addendum no. 02

date: October 23, 2026

project name: MPS Bryan Elementary Cooling Tower Replacement

project no: 26243

2 ROOF PLAN - MECHANICAL / ELECTRICAL NEW WORK
 SCALE: 1/4" = 1'-0"
 0 1 2 4 8

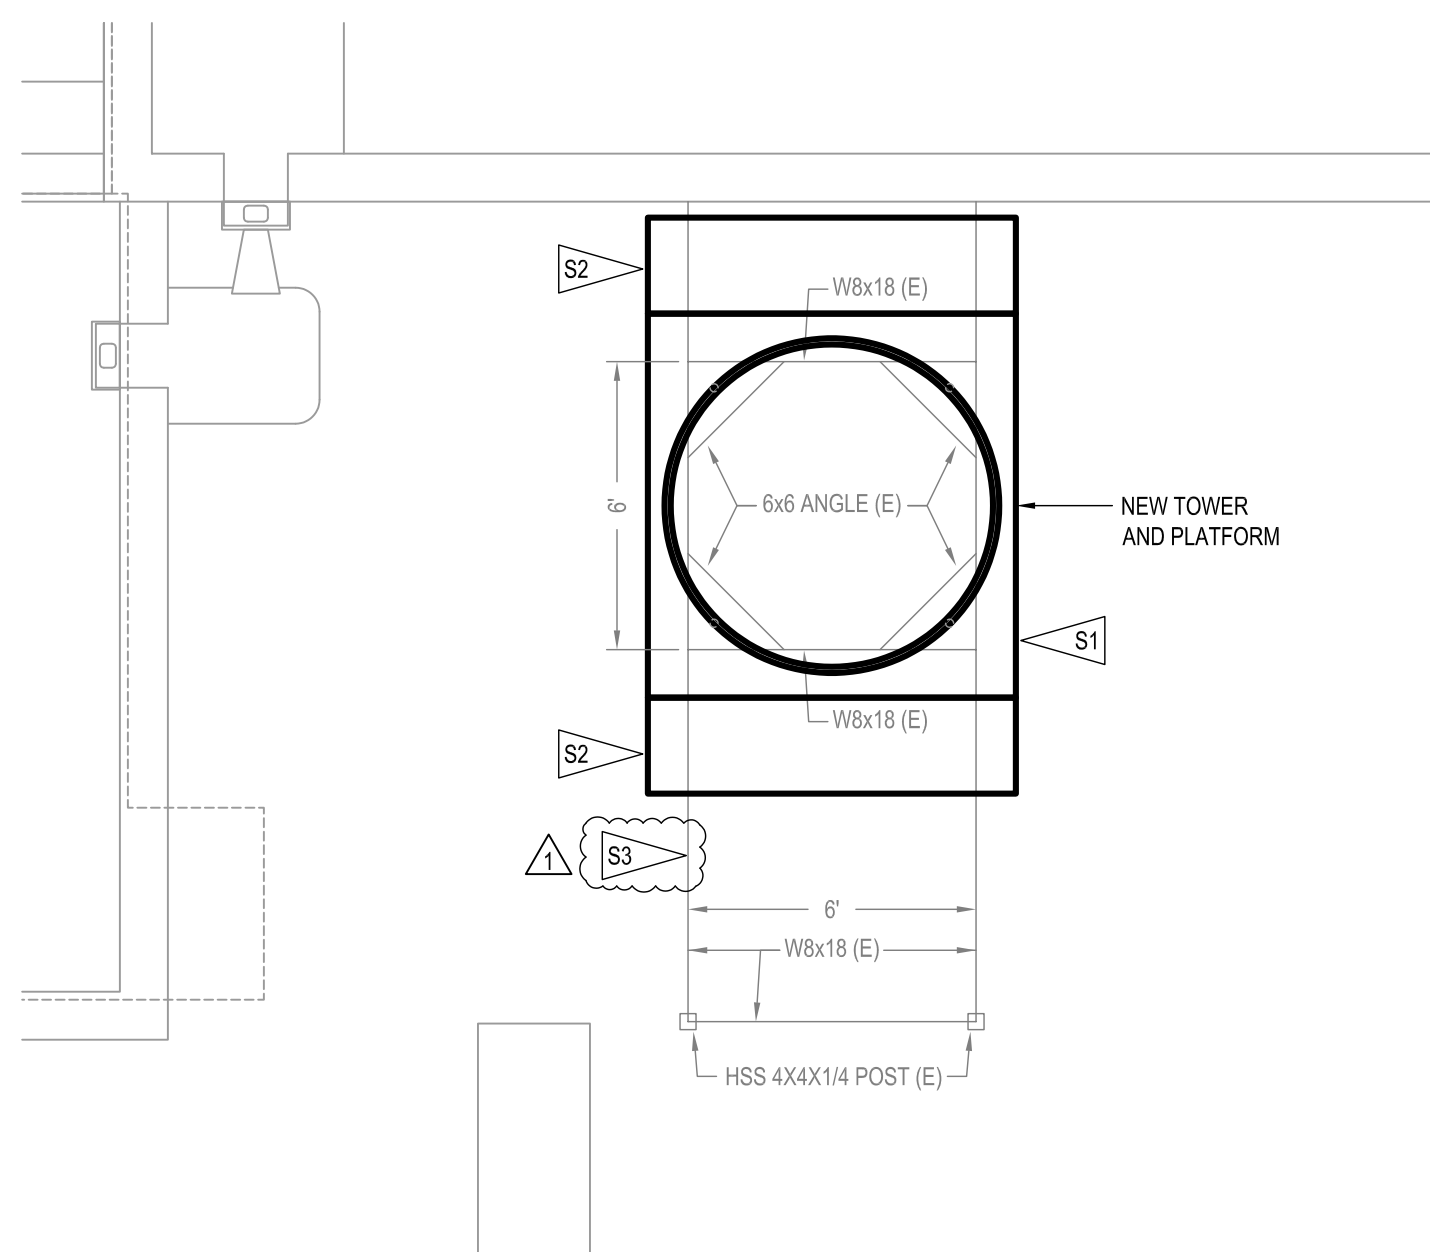
1. Sheet ME1.1 FLOOR AND ROOF PLANS – MECHANICAL / ELECTRICAL AND STRUCTURAL NEW WORK
 - a. Add keynote S3 to clean, prepare, and repaint the existing steel.
 - b. Revise keynote M3 to indicate that the new piping above the roof can match the existing CPVC piping.
 - c. Add “ROOF WORK NOTE” indicating that the existing roof requires patching due to the work it will need to be done by a roofing contractor who can work on the Carlisle roofing system which is still under warranty.

- M3** CONNECT NEW TOWER SUPPLY/RETURN PIPING TO EXISTING TOWER SUPPLY/RETURN PIPING AT APPROXIMATE LOCATION SHOWN. FIELD VERIFY EXISTING CONDITIONS. PIPING MAY MATCH EXISTING PIPING MATERIAL (CPVC).

- IF ANY ROOF PATCHING IS REQUIRED FOR THE INSTALLATION OF NEW WORK, THE CONTRACTOR SHALL ENGAGE A ROOFING CONTRACTOR WHO IS CERTIFIED TO WORK ON THE INSTALLED MEMBRANE. THE CARLISLE ROOFING SYSTEM WAS INSTALLED IN 2014 AND CARRIES A 25 YEAR WARRANTY.
